INLAND WETLANDS & WATERCOURSES COMMISSION

REGULAR MEETING

Wednesday, February 3, 2021, 7:00 p.m.

ENVIRONMENTAL PLANNER'S REPORT

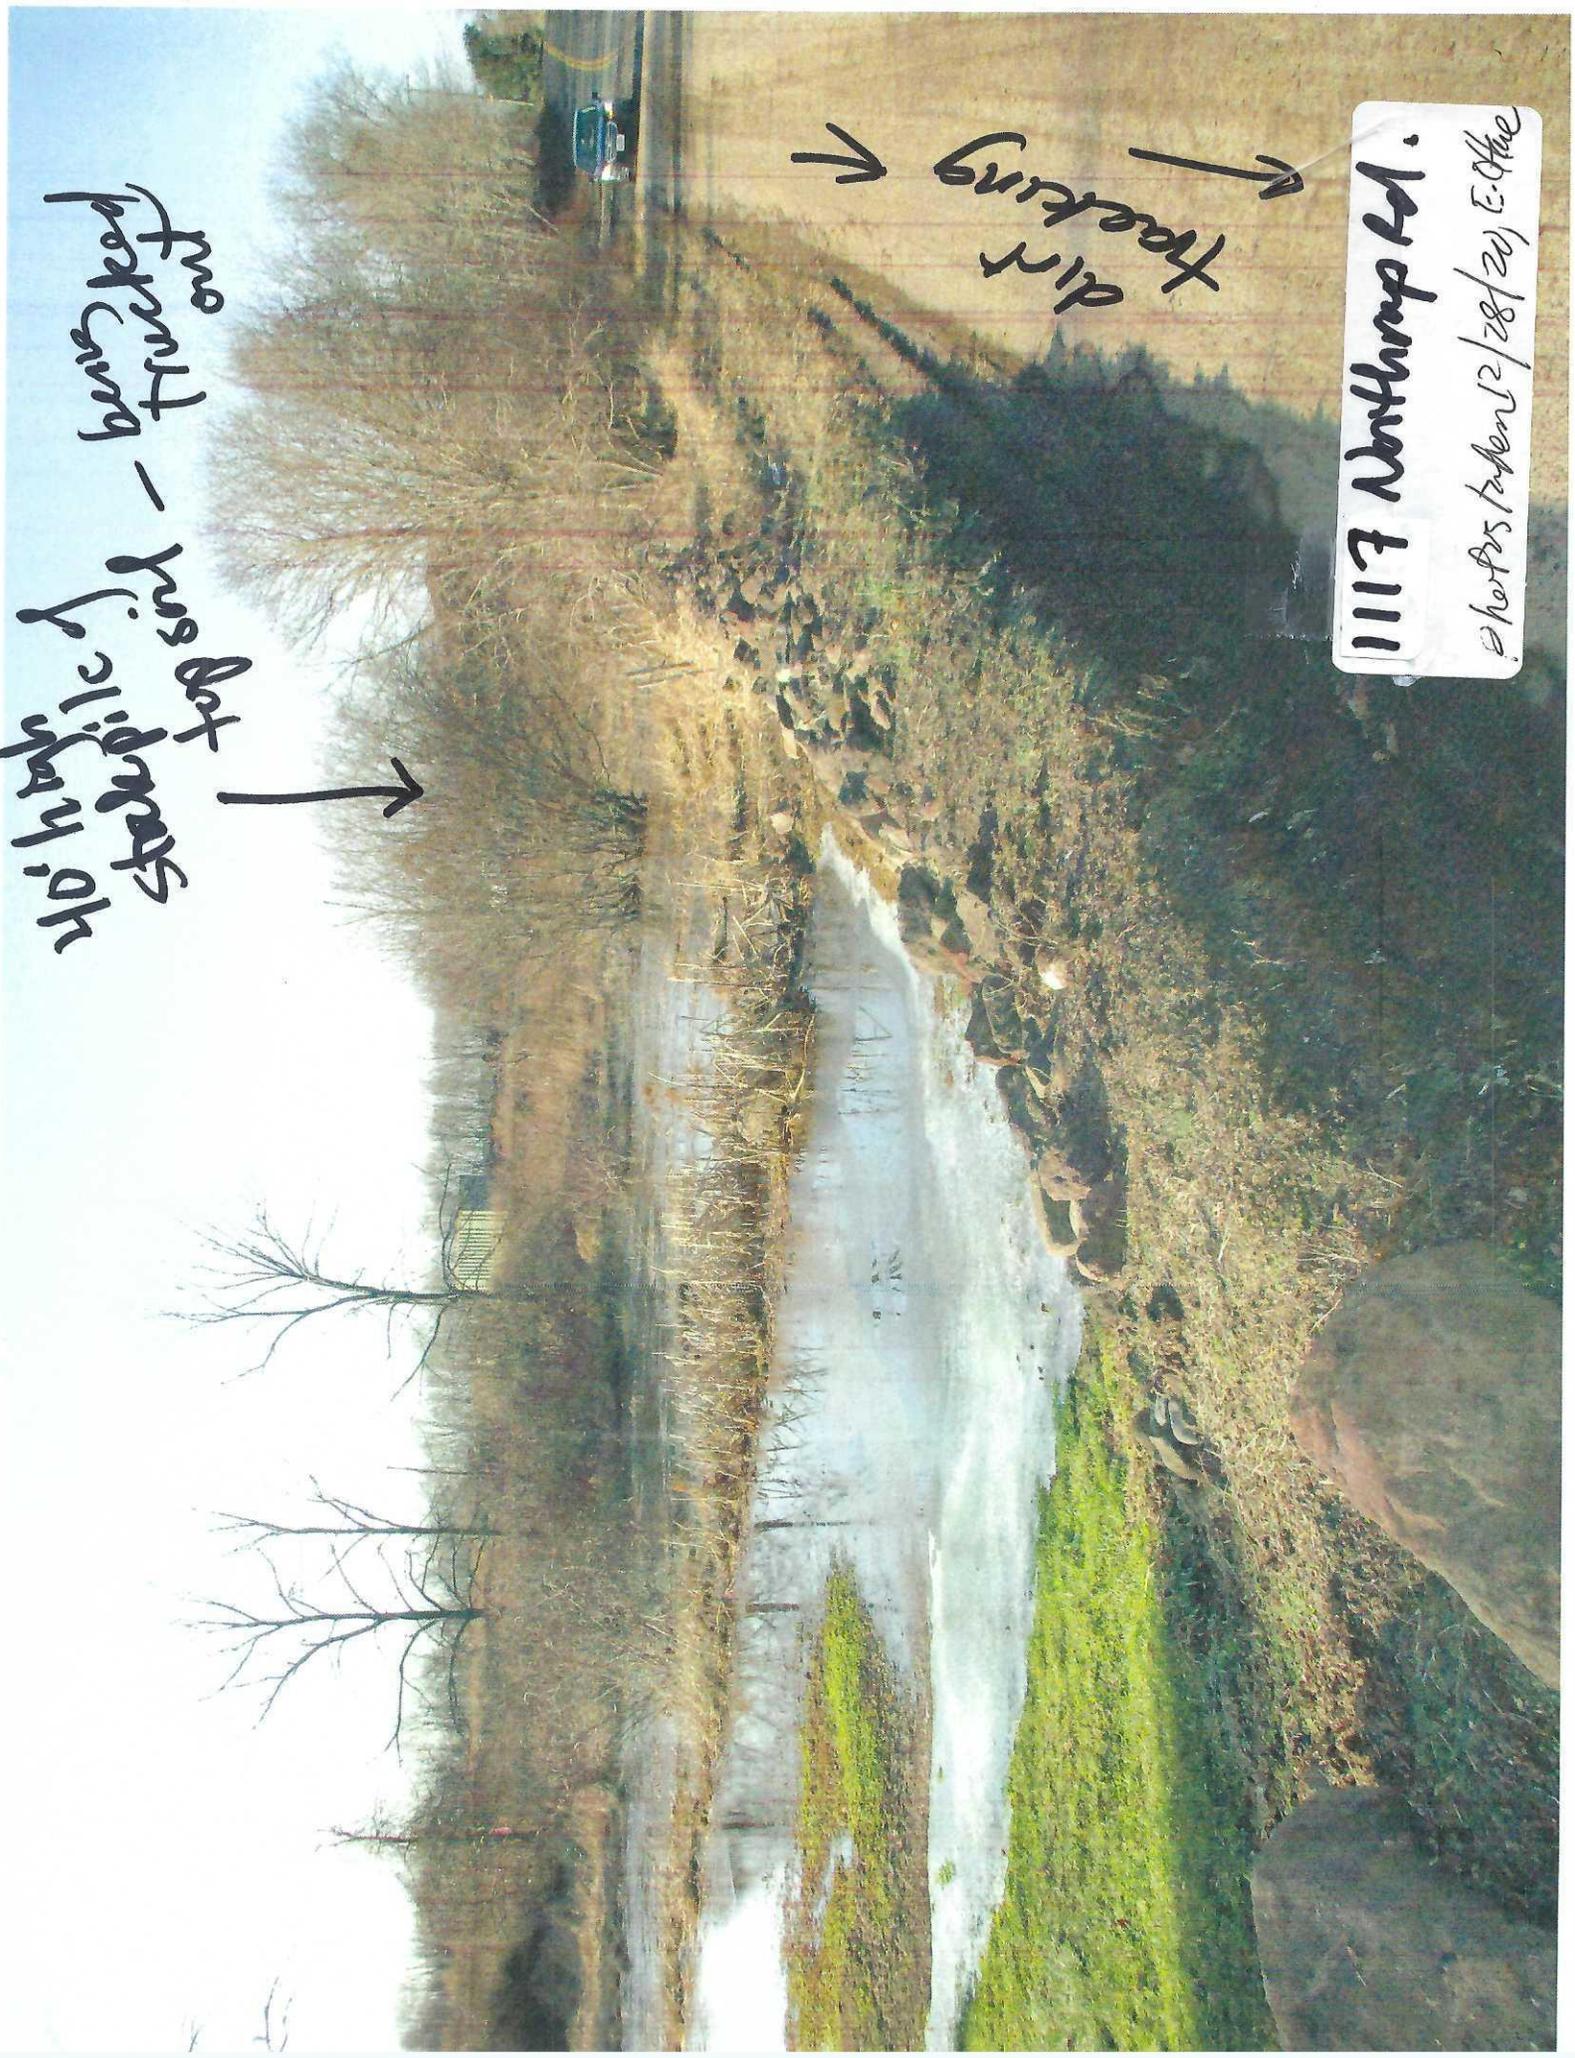
40' high of
stable soil - buried
top soil - trucked
out

dir
tracking
